TRAFFIC CONTROL PLAN
1064J - 2ND ST IMPROVEMENTS PROJECT
CURB RAMP WORK PLAN - 2ND ST FROM BRYANT ST TO BRANNAN ST

☒ NO EXCEPTIONS TAKEN
☒ MAKE CORRECTIONS NOTED
☐ REJECTED
☐ REVISE AND RESUBMIT
☐ SUBMIT SPECIFIED ITEM(S)

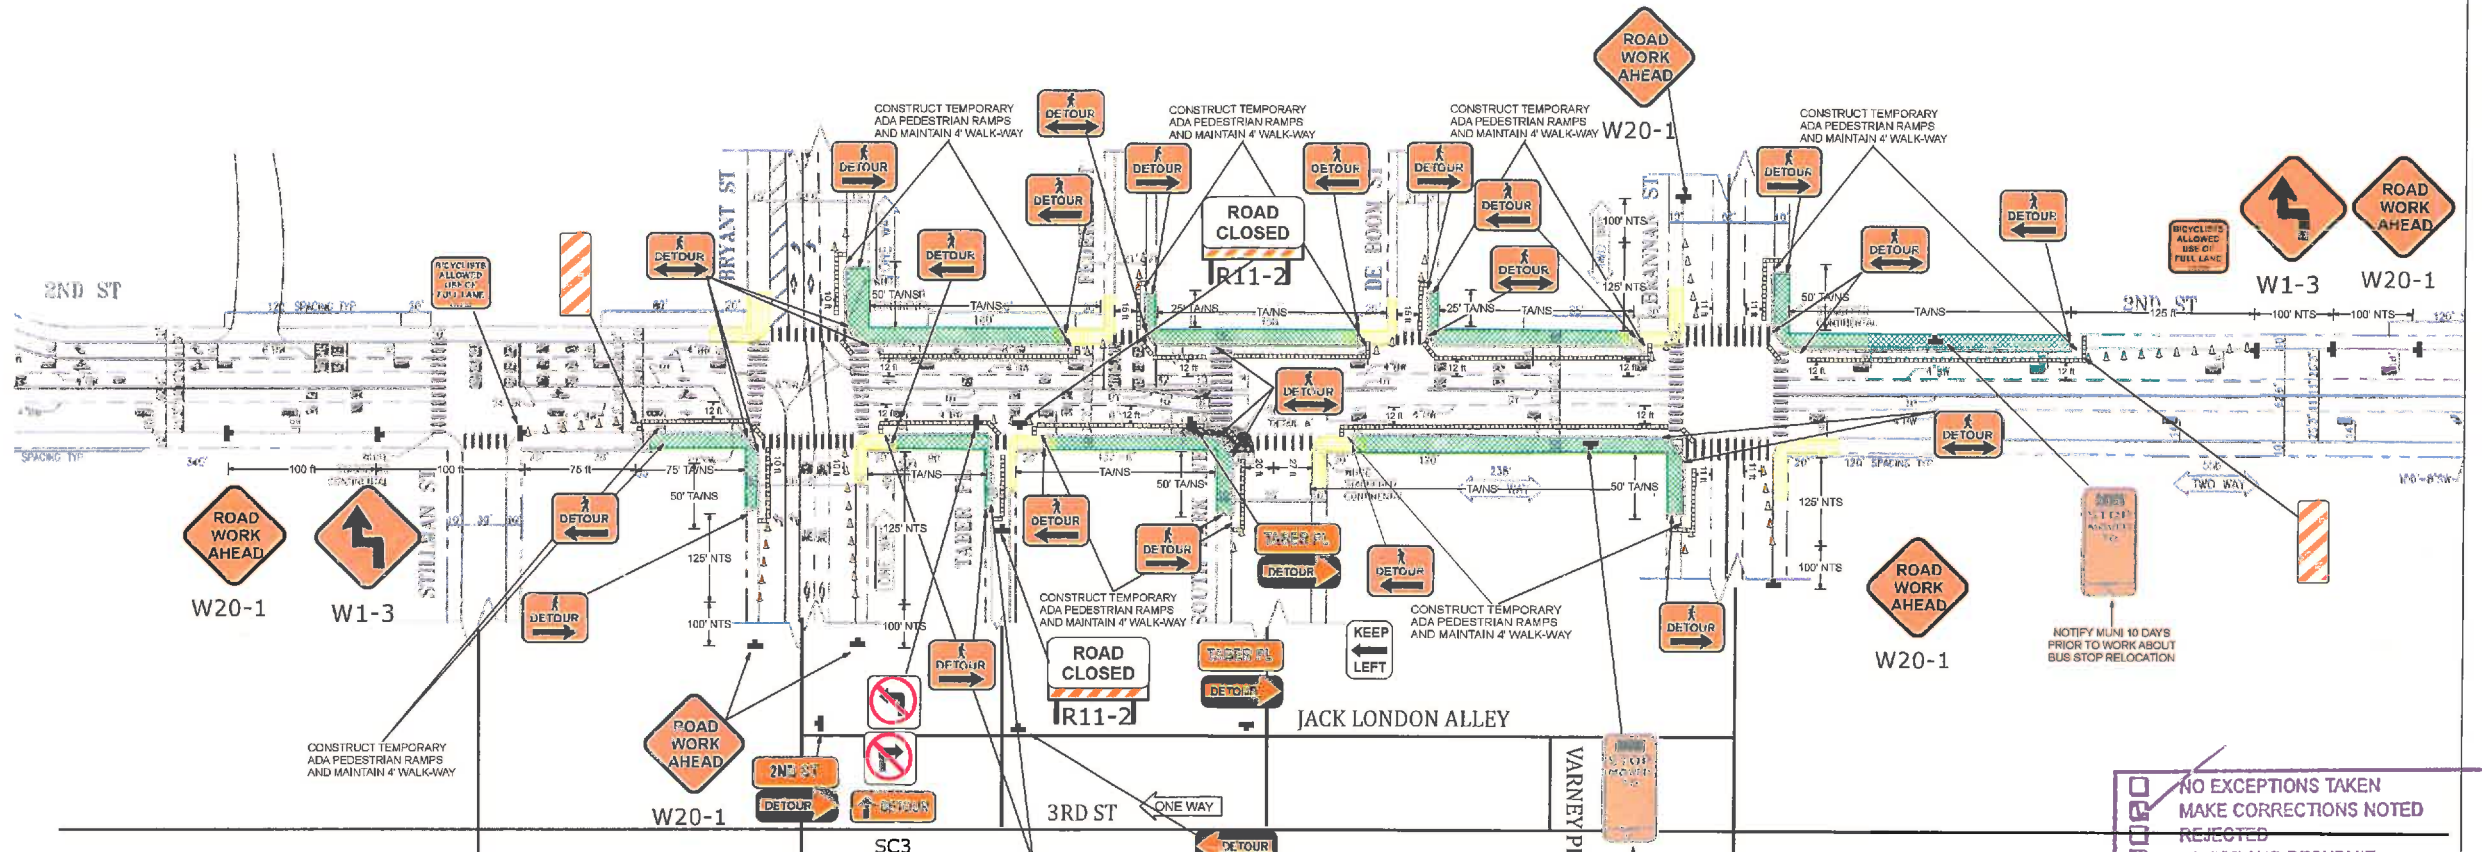
Comments:
1) WORK HOLD
2) THE CONTRACTOR SHALL BE ALLOWED TO WORK AT MAXIMUM OF 50% INTERSECTION AT ANY TIME.
3) THE CONTRACTOR SHALL NOT PREVENT OR DELAY THE OPERATION OF MASS TRANSIT VEHICLE AT ANY TIME.
4) USE A SIMILAR SIGN TO THE ONE SHOWN IN THE COMPLETE THE YELLOW CURB RAMP SIGN.
